Wiltshire Council Planning Consultation Response

Application No: **PL/2025/09846**

The Barn Dental And Cosmetic Clinic, Odstock, Salisbury, SP5 4JA
Certificate of lawfulness (proposed use) for the re-instatement and addition of windows and door on the east elevation

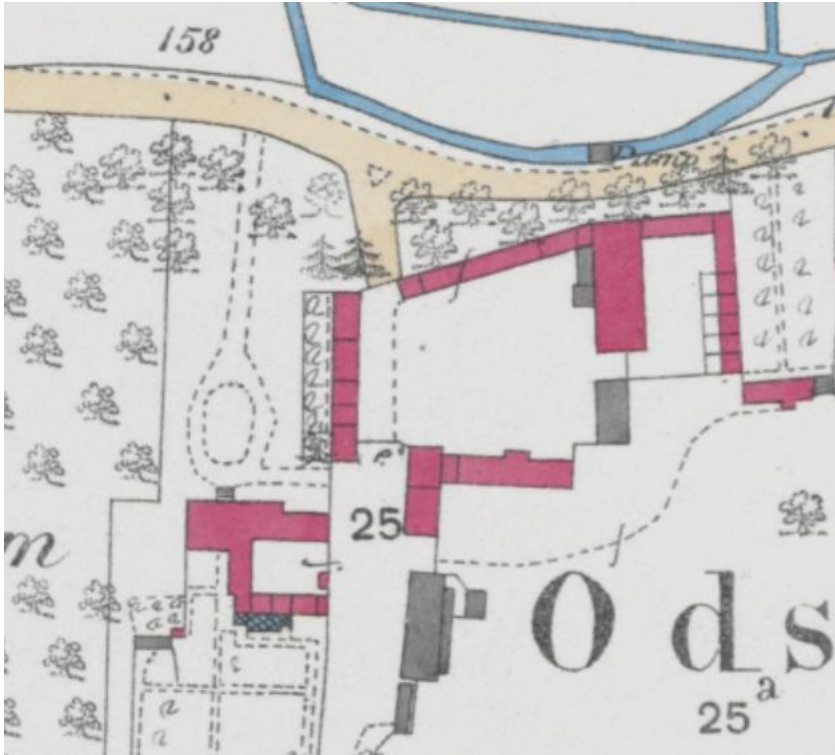
Issues: whether the building is considered to be a curtilage listed structure and as such, a certificate of lawfulness would be inappropriate.

Having looked at the first series 1844-1888 OS map, Odstock Manor is referred to as Odstock Farm and the farm buildings enclose a farmyard to the north-east of the former farmhouse. Existing houses, such as 'Old Stable House' and 'Staddle Barn House' evidence the former uses and number 201 has a similar footprint to an original outbuilding. The building in question forms the western side of the courtyard and was perhaps a stables.
